# Agenda Report

Waiver Request for Subdivision Sign, Re: Island Forest Preserve (District 2)  
Developer: IFP Development, LLC

RE: Item J.1., Waiver Request for Subdivision Sign for Island Forest Preserve – Developer: IFP Development, LLC

Signwall Detail  
Scale: 1/4" = 1'

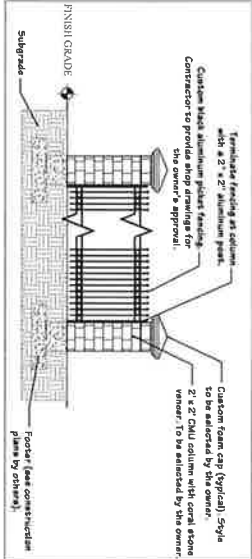
The applicant requests a waiver of Section 62-2889(b)(5) of the subdivision sign requirements to allow a subdivision sign of approximately 168 square feet which exceeds 100 square feet maximum overall size.

Section 62-2889(b)(5) states that subdivision signs shall be no higher than four feet tall and cannot exceed 100 square feet in overall size. Additionally, subdivision signs, which are part of a wall or fence, shall not exceed eight feet in height. The developer is requesting a waiver to construct a subdivision sign that exceeds 100 square feet as part of the fence and entrance features at the Island Forest Preserve subdivision in Merritt Island. The subdivision fence and sign will meet the eight-foot height requirement as 7' 8" is the proposed high point. However, the attached monument sign exceeds 100 square feet overall at approximately 168 square feet.

*physical conditions (topography etc.) to evaluate the undue hardship. The Board may consider that subdivision entry features such as signs, walls and fences are shown in subdivision plans for determining the location is consistent with the subdivision code requirements. The subdivision plan review and approval does not address the construction of the entrance sign beyond positioning of the sign. As such, subdivision signs require separate building permits where details such as height and overall size are verified, and structural design are reviewed. The subdivision sign for Island Forest Preserve will be located within a signage tract, approved as part of the subdivision plan, on the east side of the entrance at Moonrise Drive. Further, the review and approval of the subdivision plans in no way provides review, approval and permits for the entry feature shown on the subdivision plans. In this case the plans submitted during the subdivision did not indicate that the sign exceeded the maximum square footage allowed by Code. During review of the subdivision plans County staff called out that the sign required separate review and permit. As normally occurs, the applicant has now submitted a building permit to construct the entrance features, and the subdivision sign exceeds the 100 square feet overall allowed by Section 62-2889(b)(5). Since the sign details do not conform with the code, the permit review is on hold pending the outcome of this waiver application.*
